STAFF REPORT: REGULAR CALENDAR

APPLICATION NO.: 5-97-379

APPLICANT: Restaurants Unlimited Incorporated One (Kincaid's)

PROJECT DESCRIPTION: Construct a one-story plus mezzanine, 27' high, 13,426 sq. ft. restaurant, located on the Redondo Beach Pier to include 2,005 sq. ft. outdoor dining. Project will provide public valet parking in the adjacent City of Redondo Beach Pier Parking Structure.

5-97-379
Exhibit D

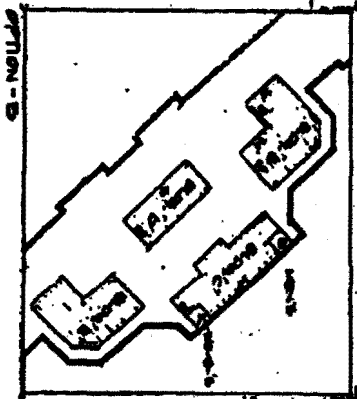
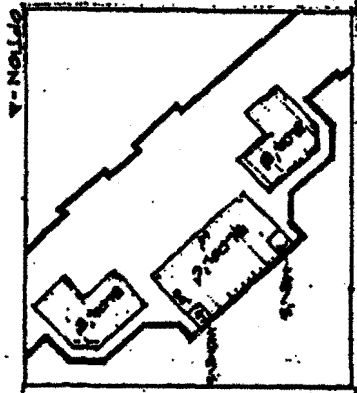
The proposed restaurant will be located approximately 40 feet inland of the seaward side of the pier deck and 20 feet from the west edge of the pier (See Exhibit D). The applicant proposes to place outdoor dining adjacent to the edge (railing) of the pier resulting in the exclusion of the general public to 170 linear feet of pier railing. Approximately 170 linear feet of public access will be restricted on the southerly and westerly sides of the restaurant.
